Crescent Heights 1901 Minor Ave

SDCI Project # 3019625

Design Review Board Recommendation Meeting
Downtown Design Review Board

August 30, 2016

3 . 4
DESIGN
Amenity Floors - Progression Plans

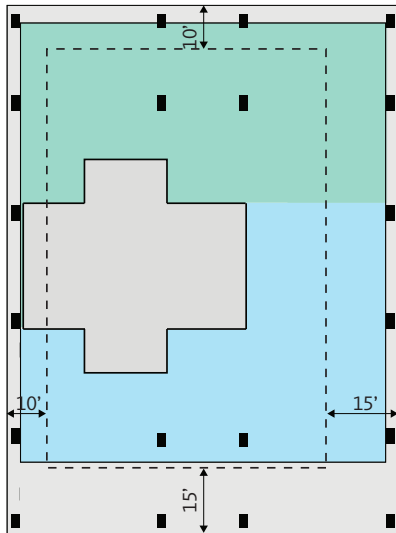
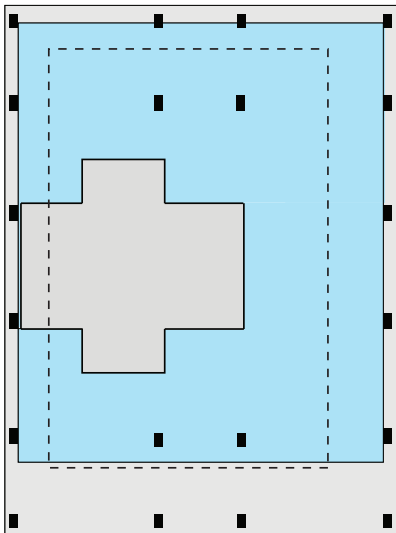
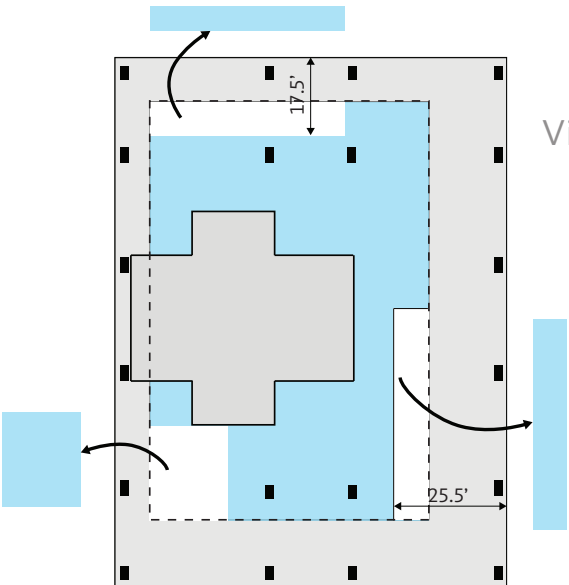
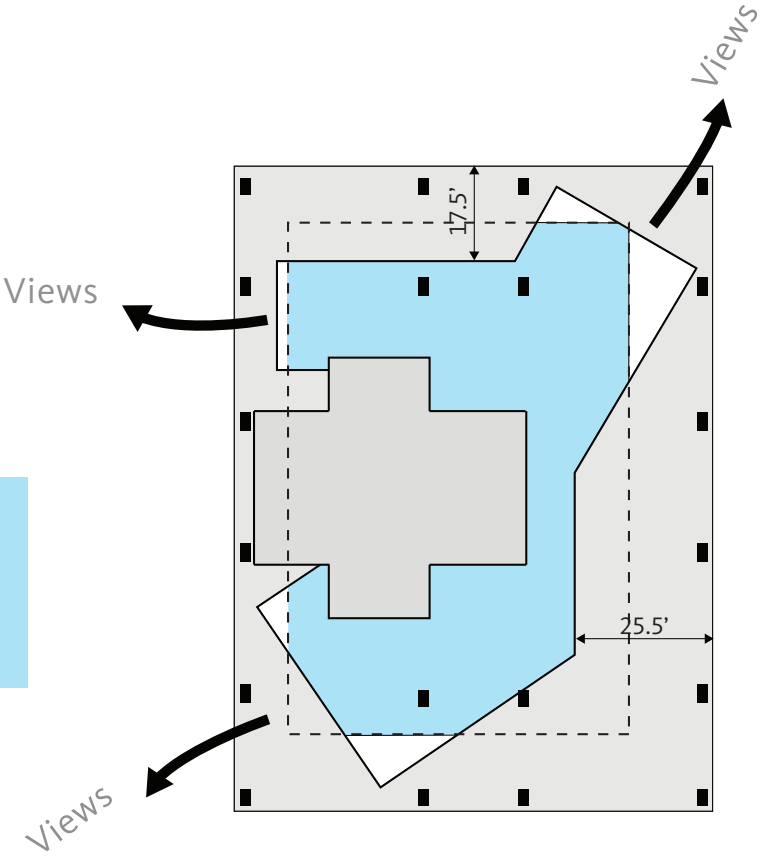
Band should be distinctly expressed
Express the columns
Explore contrast
Avoid visual fill

Relocated residential
to allow for greater setbacks

Express columns by increasing depth strategically

Amenity Floors - North Tower, Floor 26

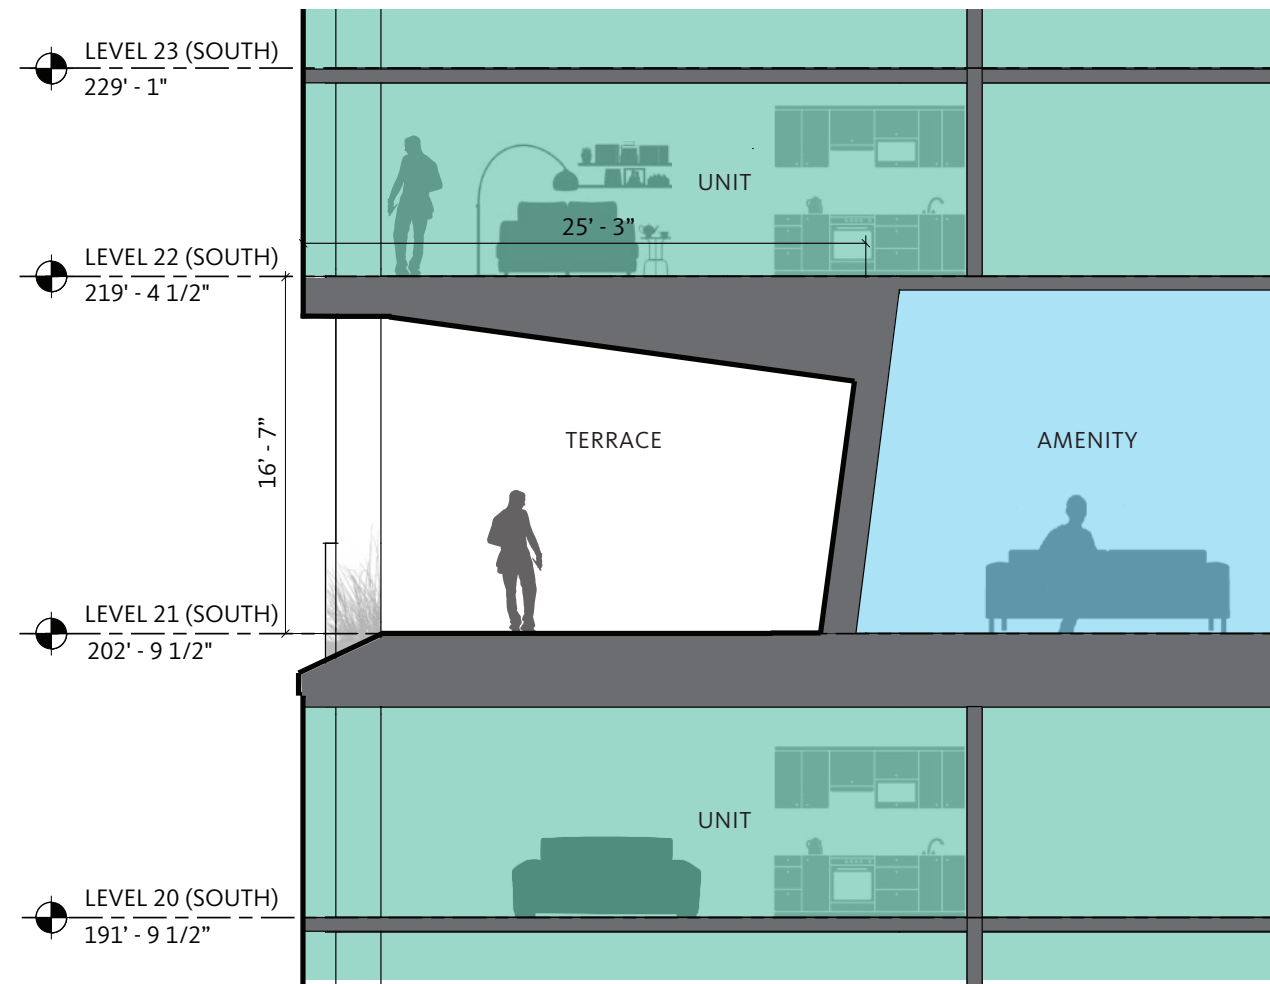
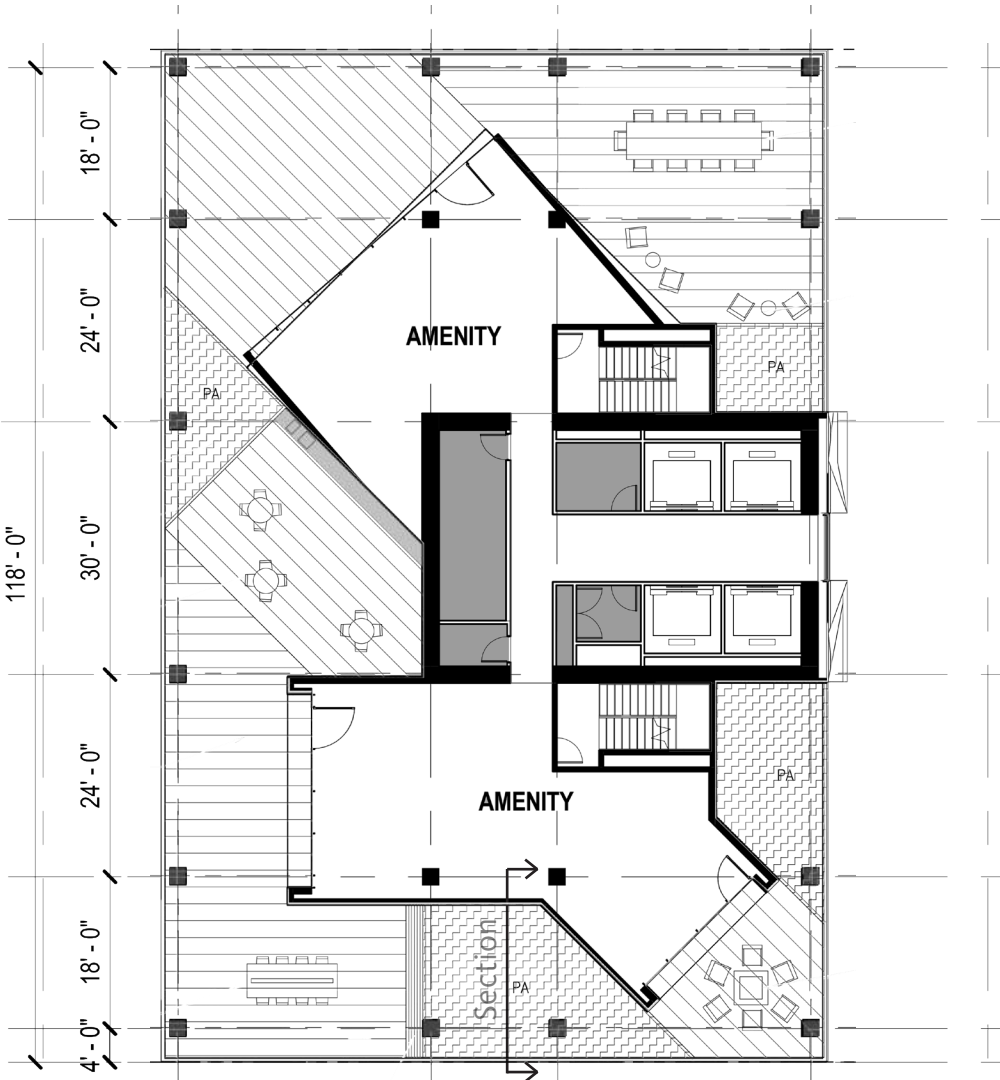
"When exterior notches occur, they should be double height to create a legible scale of 'notch' on the tall towers, and to afford those spaces sun"

"The Board supported the deep and shifting cladding language shown on page 42 left as promising for the majority of the towers and base, but only if the large notches are tall, deep and legible..."

"The Board noted the perimeter columns shown on plans would obviate the essential legibility of the notches, and recommended those columns be substantially recessed and shaped..."

- The notches have been redesigned to be one taller floor with a 16' opening expressed at the notch perimeter. Landscape and guardrails set back from the edge to emphasize the break in the tower.
- The programming of the notches has been shifted to only comprise amenity spaces with units relocated elsewhere.
- Amenity notches wrap nearly the entire perimeter the towers with most of the mass of the enclosed space set back further than 10' from the face of the tower.

3.5
DESIGN
Roof Top - North Tower

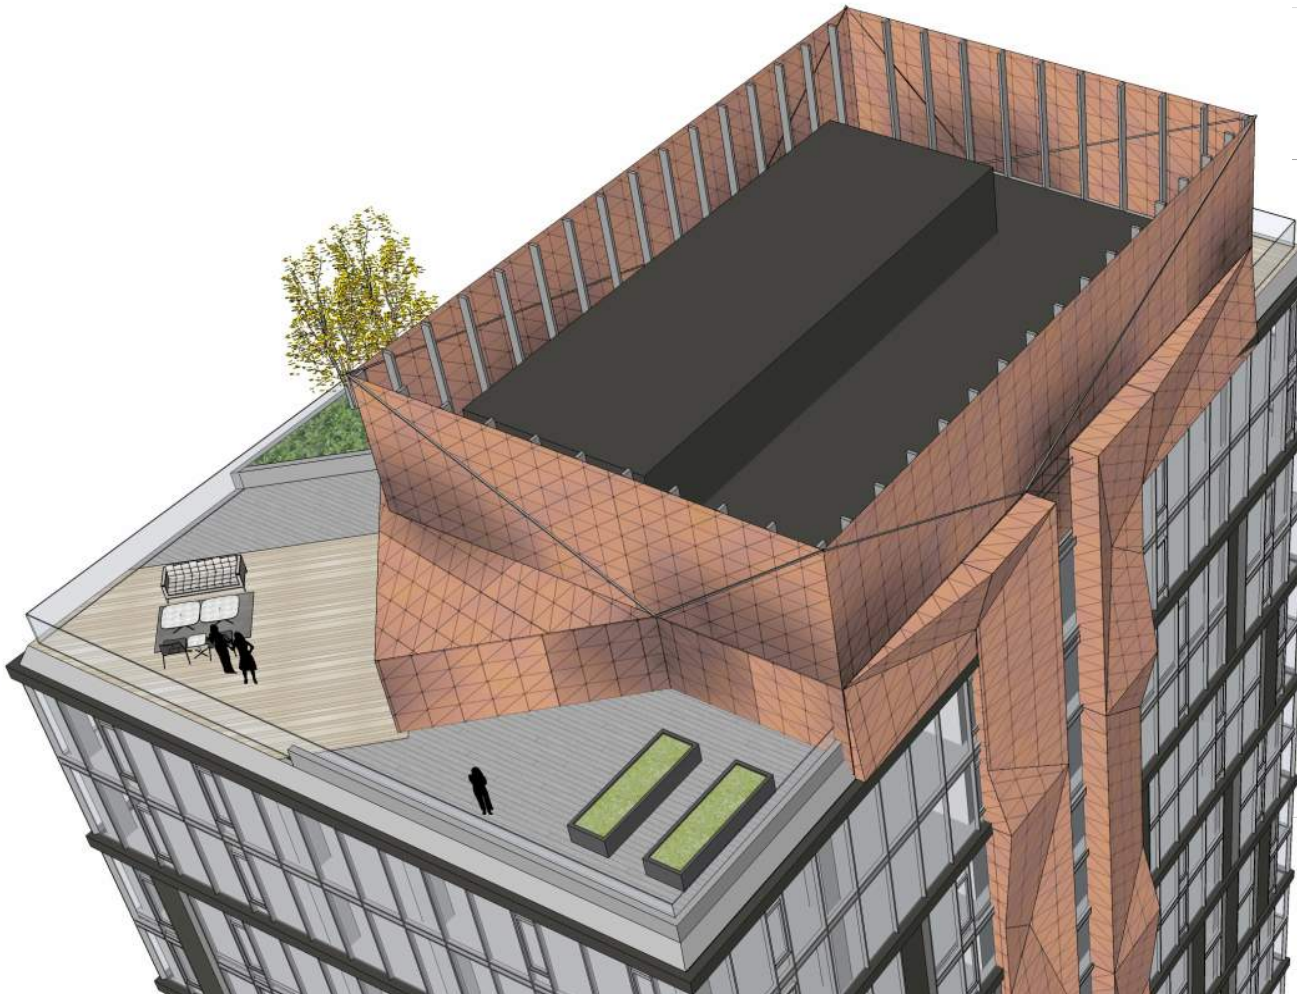
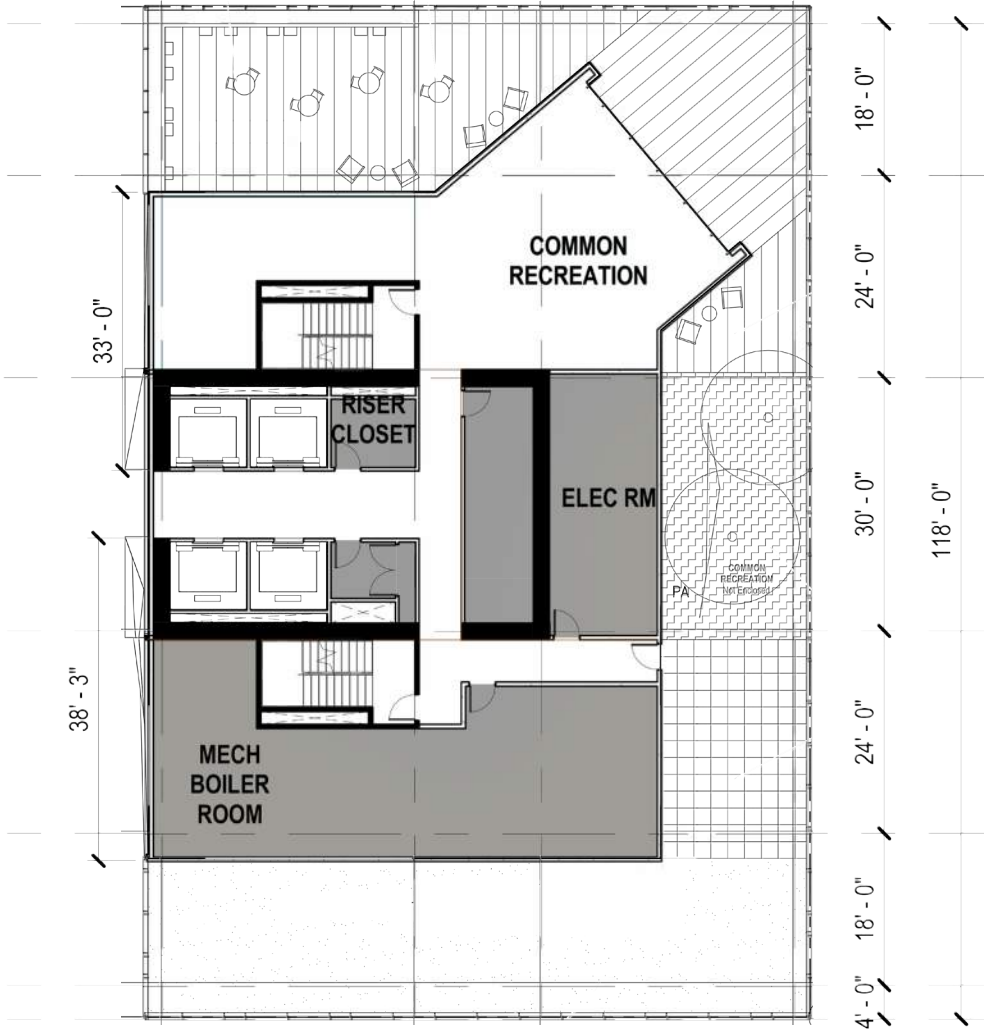
“The Board requested more details about the function, amenity and forms of the rooftops at the next meeting.”

- The form of the rooftop penthouses and amenity spaces are treated as similar to the midtower notches. These forms are set back with most of the mass of the enclosed space set back further than 10' from the face of the tower.
- The penthouses are dynamic, faceted and wood-clad to provide contrast to the remainder of the building.
- At night, the faceted forms of the penthouses will be given the same treatment as the amenity notches below. as the lines of the geometry will be highlighted and expressed with recessed linear luminaries
- Dog runs are located at the north sides of each penthouse to reduce self shading at other occupied areas

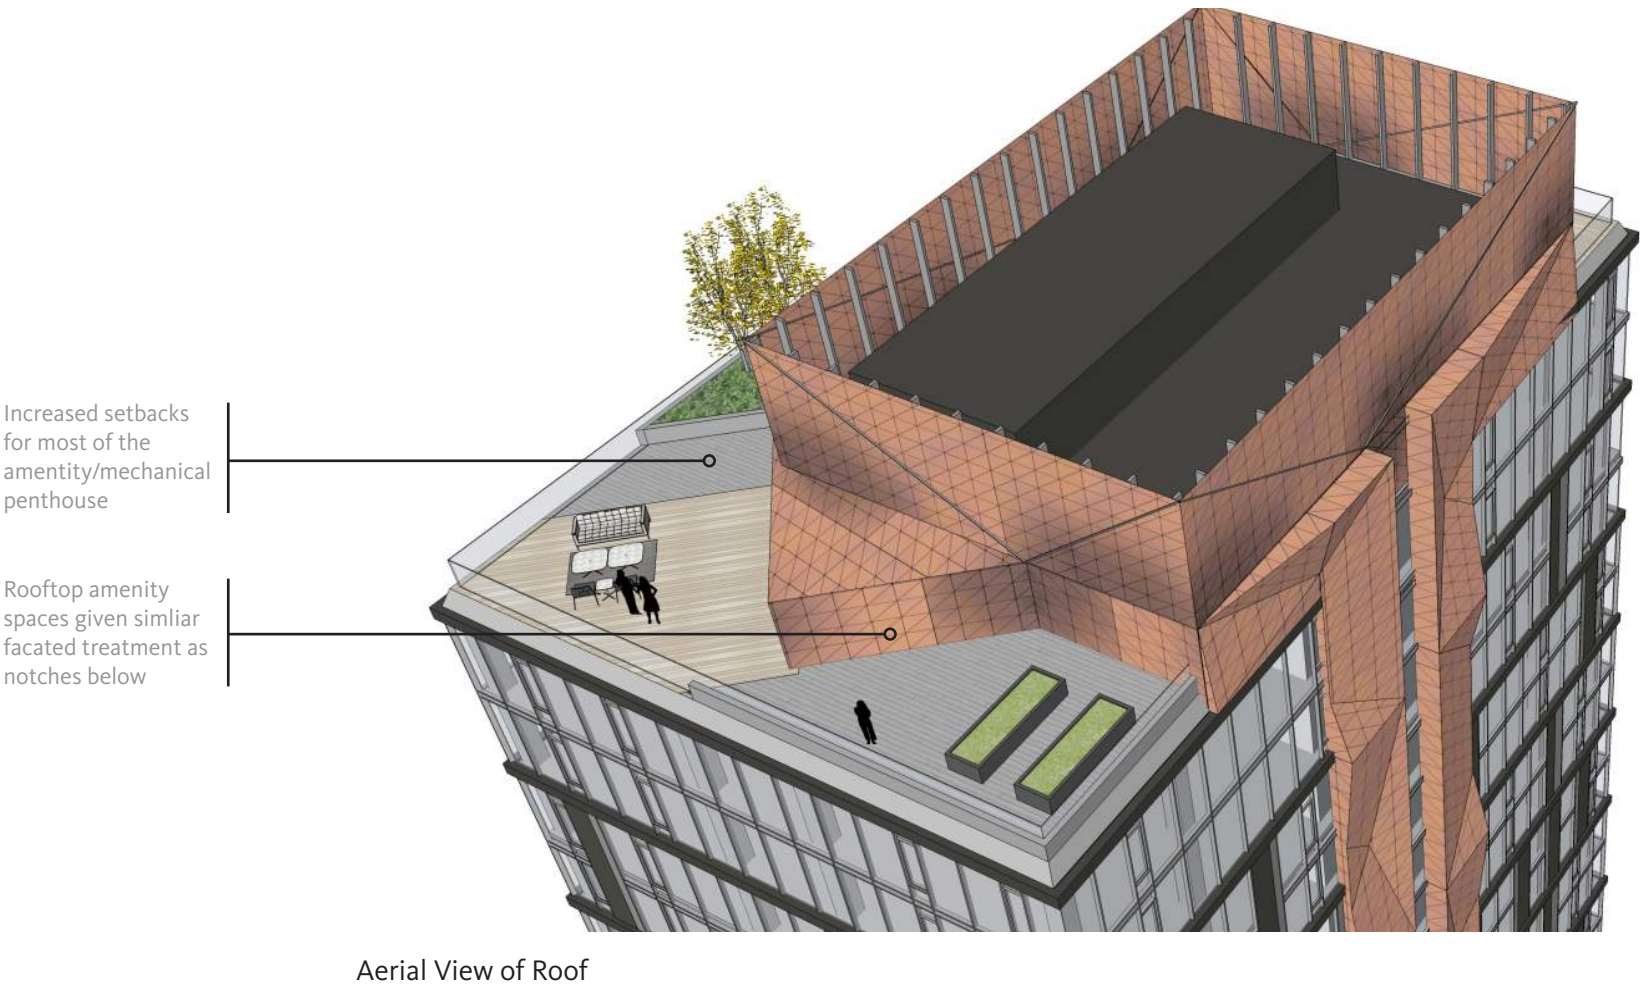
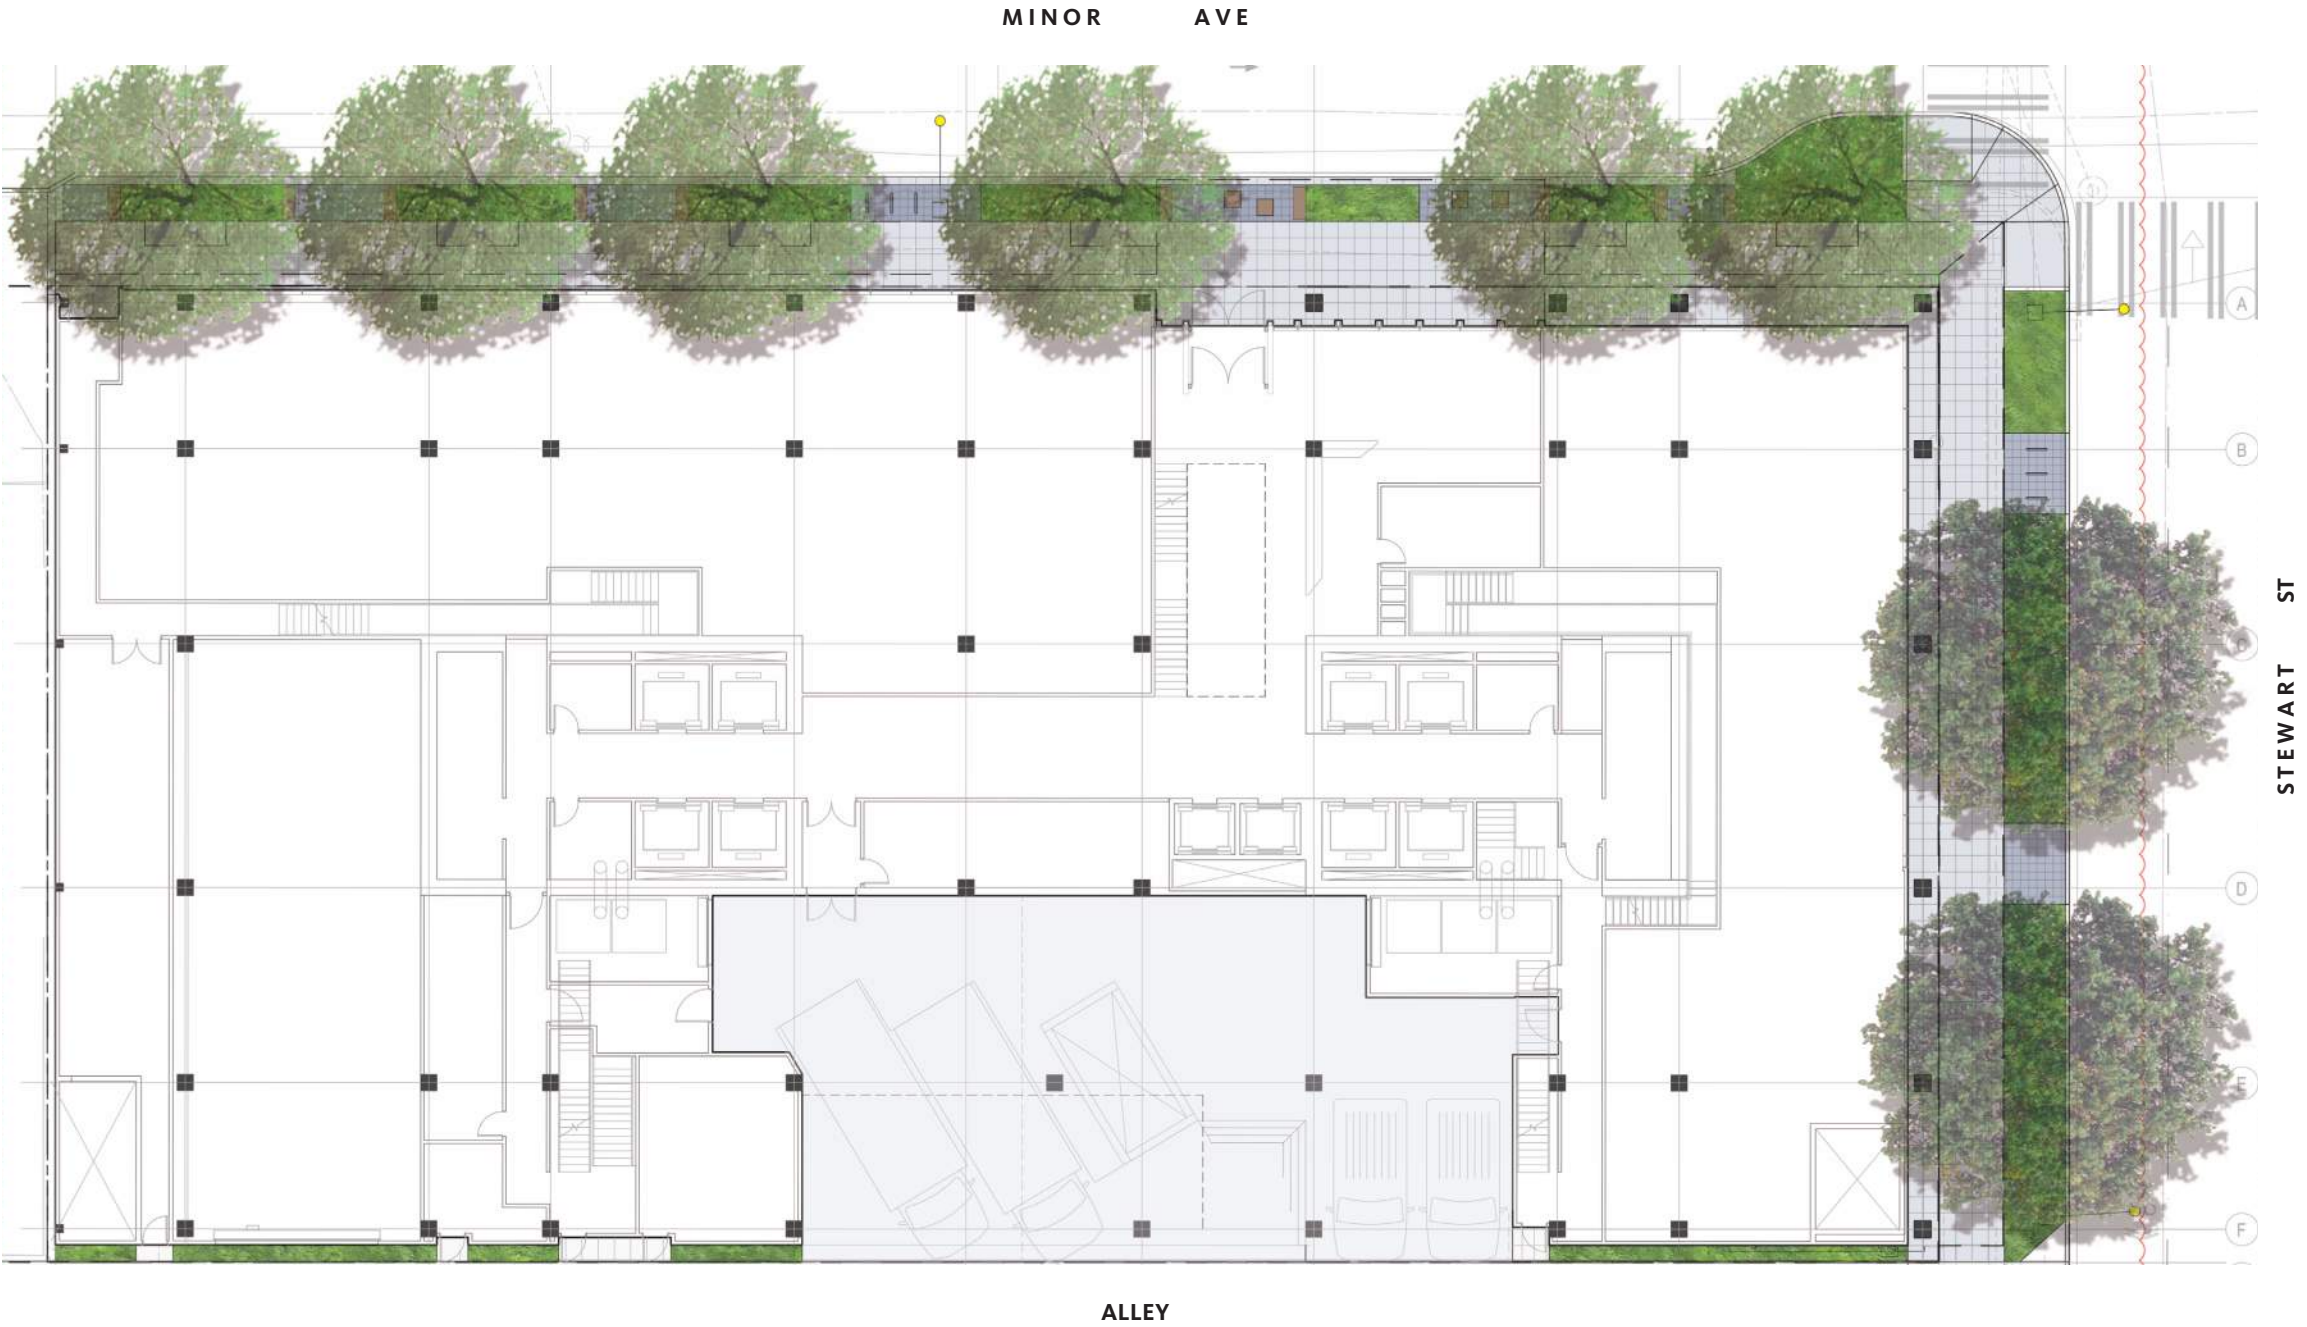
“The Board requested more details about the function, amenity and forms of the rooftops at the next meeting.”

- The form of the rooftop penthouses and amenity spaces are treated as similar to the mid-tower notches. Most of the mass of the enclosed space is set back further than 10’ from the face of the tower.
- The penthouses are dynamic, faceted and metal-clad to provide contrast to the remainder of the building.
- At night, the faceted forms of the penthouses will be given the same treatment as the amenity notches below. as the lines of the geometry will be highlighted and expressed with recessed linear luminaries
- Dog runs are located at the north sides of each penthouse to reduce self shading at other occupied areas.
